UNITED STATES PATENT AND TRADEMARK OFFICE

APPLICATION NO.	FILING DATE	FIRST NAMED INVENTOR	ATTORNEY DOCKET NO.	CONFIRMATION NO.
10/015,847	12/10/2001	Theodore J. Letavic	US 010610	3619

Office Action Summary

DETAILED ACTION

FIG. 3

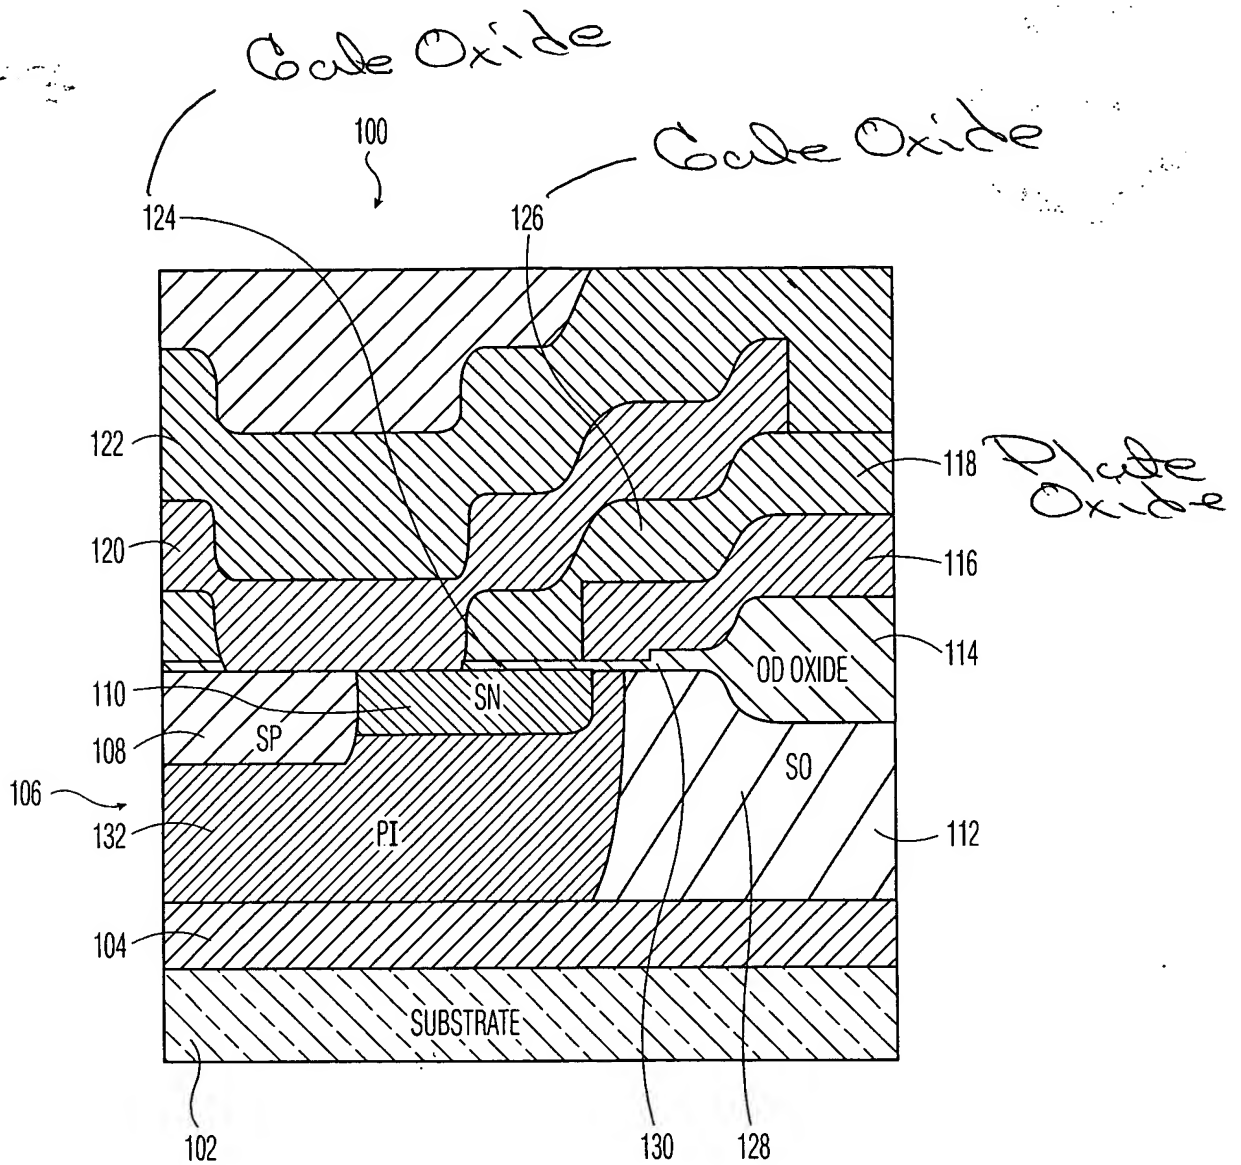
6. Applicant's arguments filed March 5, 2003 have been fully considered but they are not persuasive. Applicant argues that the “Office has misinterpreted Applicant’s Related Art, and that the cited combination of references fail to teach or suggest a second gate oxide formed over a portion of the first gate oxide.” However, Applicant’s Prior Art does disclose a second gate oxide formed over a first oxide (For Example: See Figure 2). The Examiner has attached marked up figures of the prior art and present invention to illustrate where the gate oxides are located (For Example: See Figure 2, Figure 3 and Column 6 Lines 12-23 and Column 7 Lines 1-2).
